*Access Compliance Survey Report*

**Transition Plan update  
Buildings, Facilities, and Parks  
City of Alameda**

April 4, 2008

City of Alameda  
Bay Fairview Hall  
On-site  
**1 - 0 - 1**

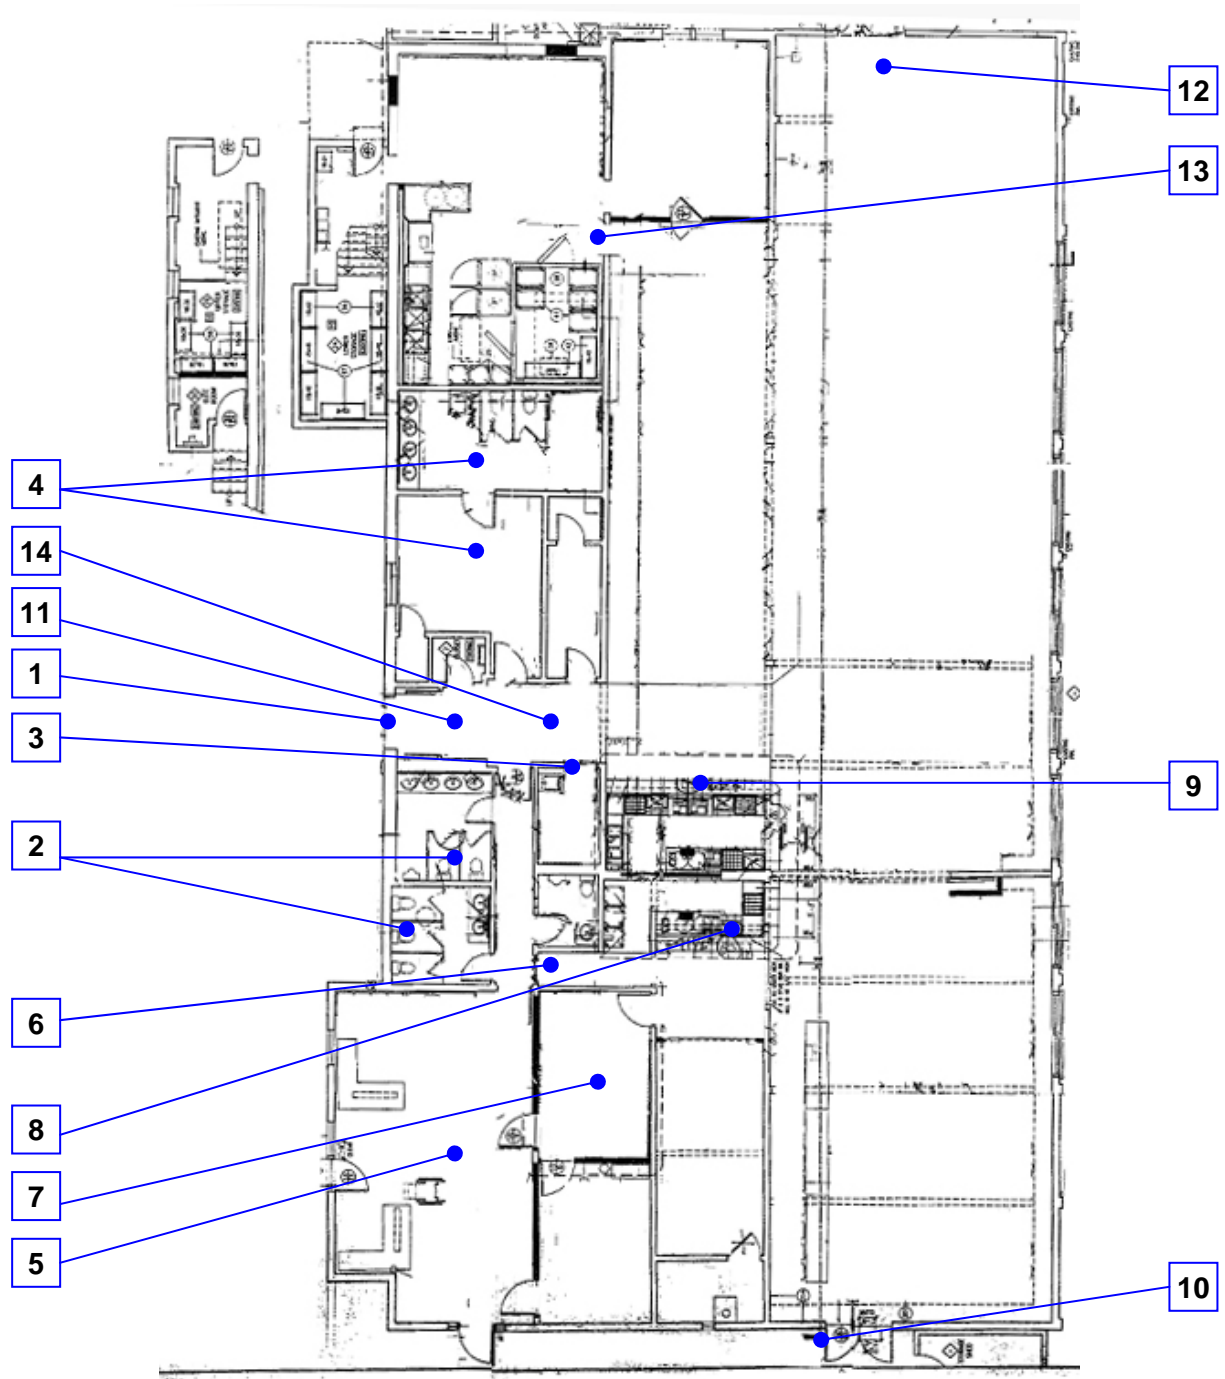
<b>3 Office Door Main</b>						
<b><u>Doormat</u></b>						
6881	<ul style="list-style-type: none"> <li>• <i>As-Built Description:</i> Doormat hinders access to disabled persons.</li> <li>• <i>Proposed Solution:</i> Provide new doormat; recess or attach at edges.</li> </ul>	PCODE <b>ID05REF</b> ADAAG <b>4.5.3</b> CSAS <b>1124B.3</b>		REF		
<b><u>Entrance Door</u></b>						
6880	<ul style="list-style-type: none"> <li>• <i>As-Built Description:</i> Public entrance not accessible to disabled persons.</li> <li>• <i>Proposed Solution:</i> Rebuild walk &amp; landing for accessible width, length, and slope.</li> </ul>	PCODE <b>ID04NT</b> ADAAG <b>4.14.1</b> CSAS <b>1134B.2.1</b>	1	LF	\$2,000	<b>\$2,000</b>

6883	<ul style="list-style-type: none"> <li>• <i>As-Built Description:</i> Travel path from double exit door is barricaded by storage and locked/chained fence gate.</li> <li>• <i>Proposed Solution:</i> Provide unobstructed exit discharge to public way.</li> </ul>	PCODE <b>EF13NT</b> ADAAG <b>4.3.2 or 4.1.2 (1)</b> CSAS <b>1114B.1.2</b>	1	JOB	\$250	<b>\$250</b>
------	--	---	---	-----	-------	--------------

6884	<ul style="list-style-type: none"> <li>• <i>As-Built Description:</i> Door inaccessible due to threshold or step at door more than 3/4" high, up to 6" high.</li> <li>• <i>Proposed Solution:</i> Remove existing paving at door and provide landing with edge ramping (slope 1:20 max) as needed.</li> </ul>	PCODE <b>ID02A</b> ADAAG <b>4.13.8</b> CSAS <b>1133B.2.4.1</b>	50	SF	\$130	<b>\$6,500</b>
------	---	--	----	----	-------	----------------

6885	<ul style="list-style-type: none"> <li>• <i>As-Built Description:</i> Signage: No "Tow Away" sign at parking lot entrance (required in CA only).</li> <li>• <i>Proposed Solution:</i> Provide "Tow Away" sign at parking lot entrance when altering area.</li> </ul>	PCODE <b>EA04C</b> CSAS <b>1129B.5</b>	1	JOB	\$325	<b>\$325</b>
------	--	---	---	-----	-------	--------------

City of Alameda  
City Hall  
First Floor, Interior  
**8 - 1 - 1**

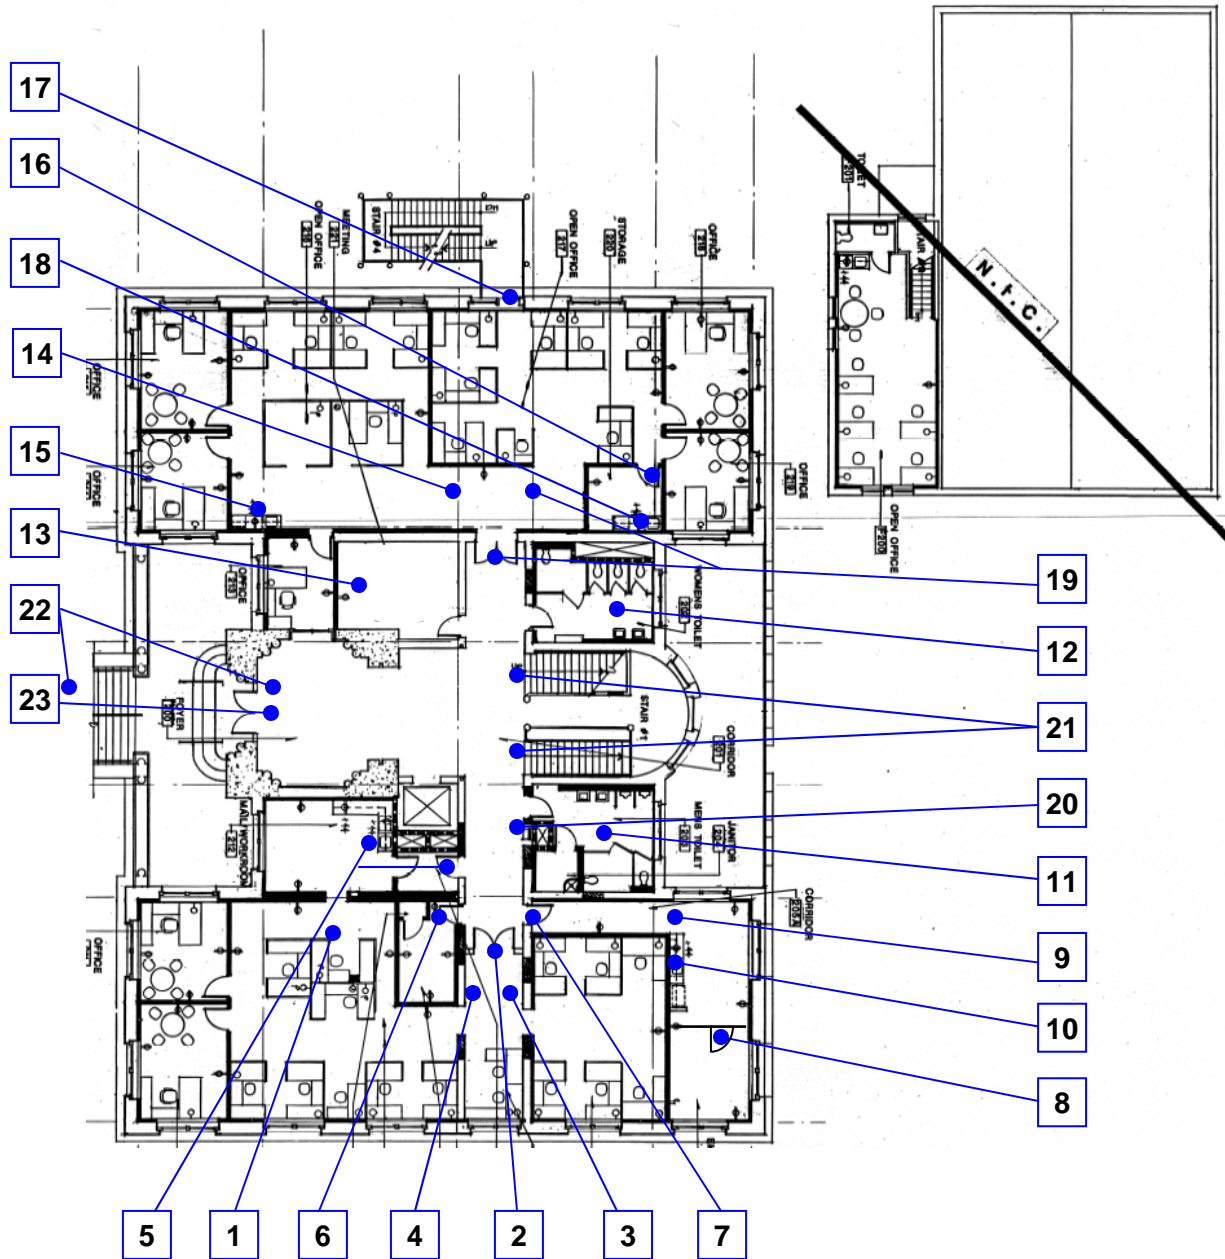
<b>8 North-East Office</b>						
<b><u>Door</u></b>						
7107	<ul style="list-style-type: none"> <li>• <i>As-Built Description:</i> Front approach: less than 60" clear space perpendicular to closed door at swing side.</li> <li>• <i>Proposed Solution:</i> Remove or relocate storage items or furniture.</li> </ul>	PCODE <b>ID15A</b> ADAAG <b>Fig. 25</b> CSAS <b>1133B.2.4.2</b>	1	JOB	\$50	<b>\$50</b>
<b>9 North-East Office</b>						
<b><u>Door Closer</u></b>						
9277	<ul style="list-style-type: none"> <li>• <i>As-Built Description:</i> Excessive effort required to operate door and/or door closer delay-time of less than 3 seconds.</li> <li>• <i>Proposed Solution:</i> Adjust regular door closer to accessible standards (5 lbs max).</li> </ul>	PCODE <b>ID14</b> ADAAG <b>4.13.10 &amp; 11</b> CSAS <b>1133B.2.5</b>	1	JOB	\$25	<b>\$25</b>

City of Alameda  
Krusi Park  
Rec. Building, Interior  
**16 - 1 - 1**

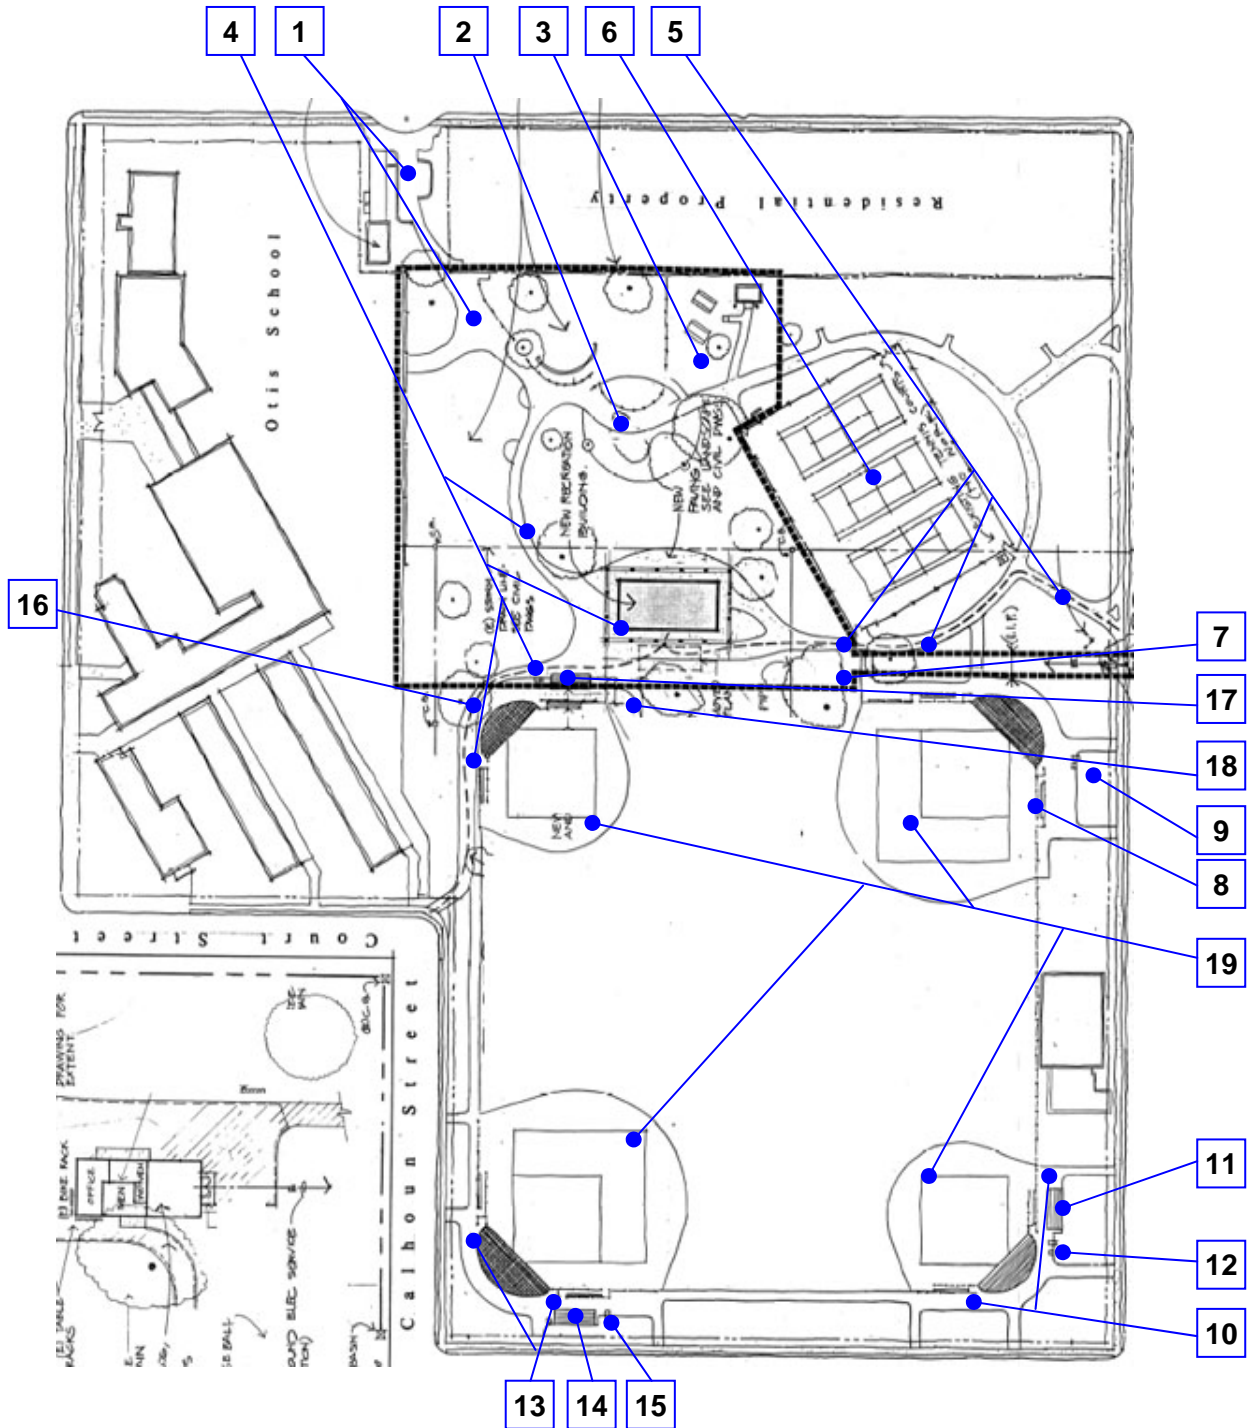
Item	Existing Architectural Barrier and Proposed Solution	Codes / Mitigation Info	Qty	Unit	Cost	Total
7402	<ul style="list-style-type: none"> <li>• <i>As-Built Description:</i> Drinking fountain lacks protection for visually impaired persons.</li> <li>• <i>Proposed Solution:</i> Provide alternate wing walls, 32" wide min x 18" min out from wall, which are drinking fountain height and not more than 6" from floor.</li> </ul>	PCODE <b>IA05CREF</b> ADAAG <b>4.4.1</b> CSAS <b>Fig. 11B-3</b>		REF

City of Alameda  
Lincoln Park Lodge  
Restrooms, Interior  
**28 - 4 - 1**

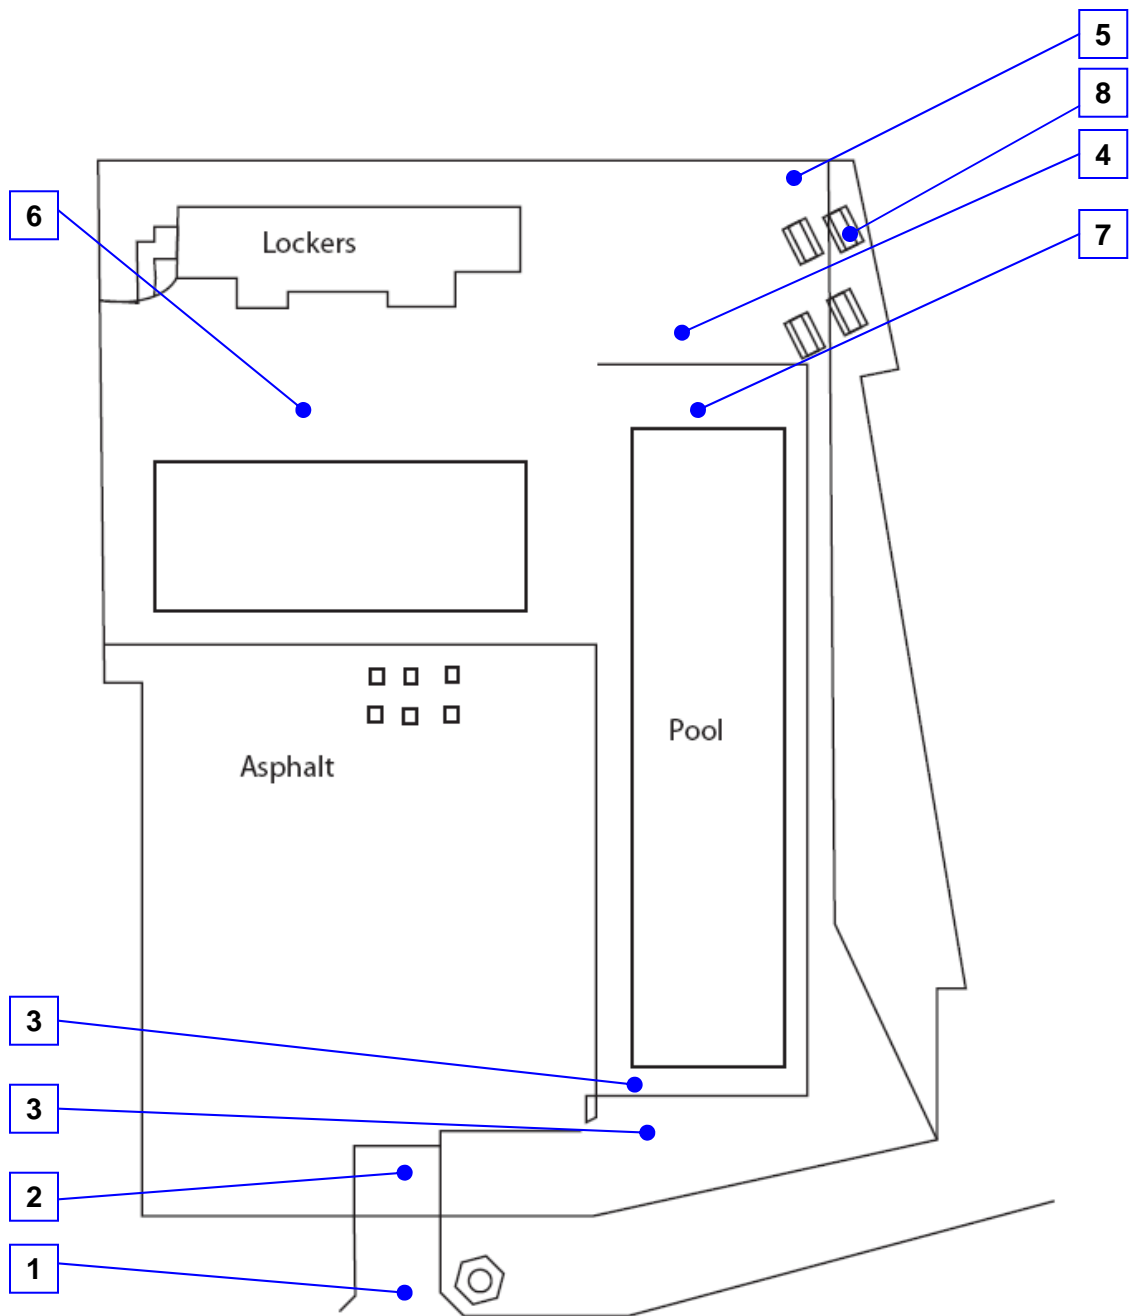
7735	<ul style="list-style-type: none"> <li>• <i>As-Built Description:</i> Drinking fountain lacks protection for visually impaired persons.</li> <li>• <i>Proposed Solution:</i> Provide alternate wing walls, 32" wide min x 18" min out from wall, which are drinking fountain height and not more than 6" from floor.</li> </ul>	PCODE <b>IA05CREF</b> ADAAG <b>4.4.1</b> CSAS <b>Fig. 11B-3</b>		REF
